Project	<b>IEEE 802.16 Broadband Wireless Access Working Group</b> < <a href="http://ieee802.org/16">http://ieee802.org/16</a> >
Title	<b>Comment contribution</b>
Date Submitted	2002-05-15
Source(s)	<a href="#">Nico van Waes</a>
Re:	802.16-02/22
Abstract	license-exempt changes
Purpose	Consideration & decision
Notice	This document has been prepared to assist IEEE 802.16. It is offered as a basis for discussion and is not binding on the contributing individual(s) or organization(s). The material in this document is subject to change in form and content after further study. The contributor(s) reserve(s) the right to add, amend or withdraw material contained herein.
Release	The contributor grants a free, irrevocable license to the IEEE to incorporate text contained in this contribution, and any modifications thereof, in the creation of an IEEE Standards publication; to copyright in the IEEE's name any IEEE Standards publication even though it may include portions of this contribution; and at the IEEE's sole discretion to permit others to reproduce in whole or in part the resulting IEEE Standards publication. The contributor also acknowledges and accepts that this contribution may be ma

**Figure 231—Channelization, 20 MHz**

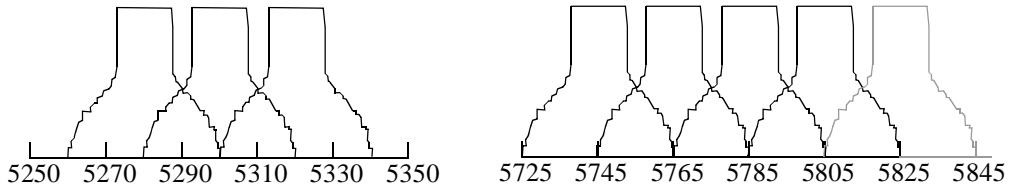
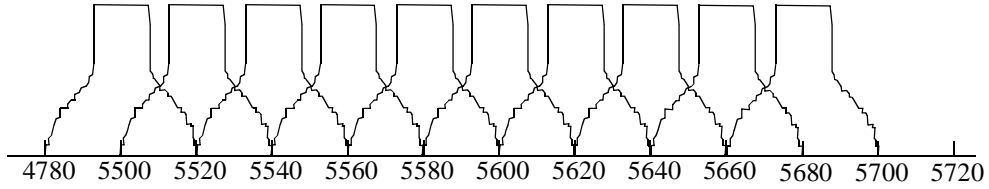
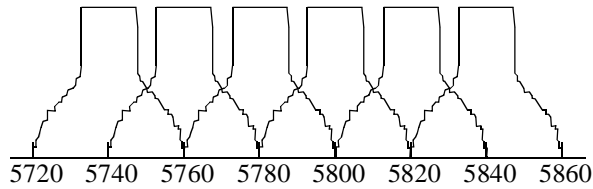
*page 214, line 35, Replace clause with*

Channel center frequency =  $5000 + 5 n_{ch}$  (MHz)

where  $n_{ch} = 0,1,\dots,199$ . This definition provides a 8-bit unique numbering system of all channels with 5 MHz spacing from 5 GHz to 6 GHz to provide flexibility to define channelization sets for all current and future regulatory domains. The set of operating channels numbers by regulatory domain is defined in Table 247. The support of any individual band is not mandatory, but all channels within a band shall be supported.

Figure 214 depicts the 20 MHz channelization scheme listed in Table 247. Channelization has been defined to be compatible with IEEE 802.11a for interference mitigation purposes, even though this results in less efficient spectrum usage in the middle U-NII band.
